## SERVICE INFORMATION LETTER LG 05/03

### LANDING GEAR CONTROL AND INTERFACE UNITS 6647 SERIES

(Used on A318, A319, A320 and A321 Aircraft)

#### CORRECTIVE ACTION FOR CRACKED SOLDER JOINTS ON TRANSISTORS

Figure 1

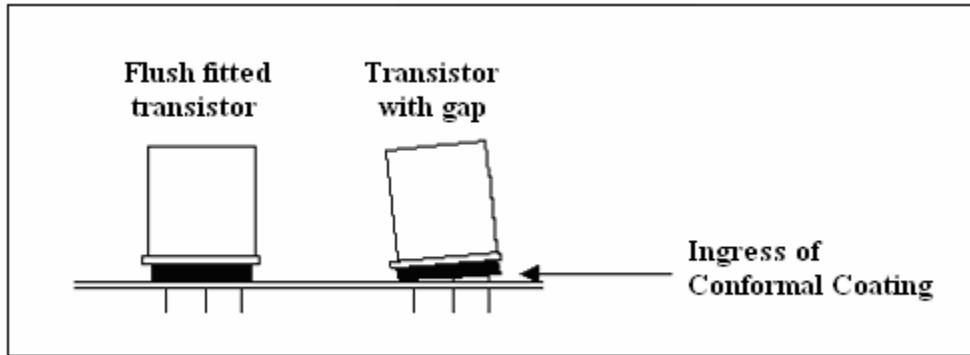
Each transistor is fitted on a thin spacer. The probable failure mechanism is due to the ingress of conformal coating beneath some transistors. This is a result of production variations that can, in some instances, allow a gap beneath the transistor into which conformal coating can penetrate. The coating expands and contracts with temperature changes, causing stress cycles that eventually crack the solder joint. (See Fig. 1)

If an assembly is returned from service with cracked solder joints on a T0-5 / TO-39 style transistor, it is not sufficient to simply re-solder the joints.

Although at the time of rework they would be sound, the conditions that led to the crack are still present, and after further temperature cycles the joint will fail again.

- Clear coating (1-2577) from PCB solder side in transistor location.
  - De-solder joints.
  - Remove transistor (with heatsink still attached).
  - Carefully clean coating from the PCB. Use Toluene to soften the coating, then a soft scraper to remove it from the PCB. Ensure the plated-through-holes are uncontaminated.

- Place the transistor(s) in a small container of Toluene for 5 – 10 minutes.
  - Remove the pad and the coating on the underside of the transistor. Discard the pad.

- Thoroughly clean the transistor's underside, and the leads.
  - Fit new pad (P/N 28682-193-0-8) and ensure all items are flush to the board.
  - Fit transistor, then solder leads and clean joints using IPA (Isopropyl Alcohol).

- Re-coat with conformal coating on solder side of PCB.
  - Coat the top of the transistor around the heatsink, as this aids its retention.
- Sparingly** re-coat the sides of the transistor.
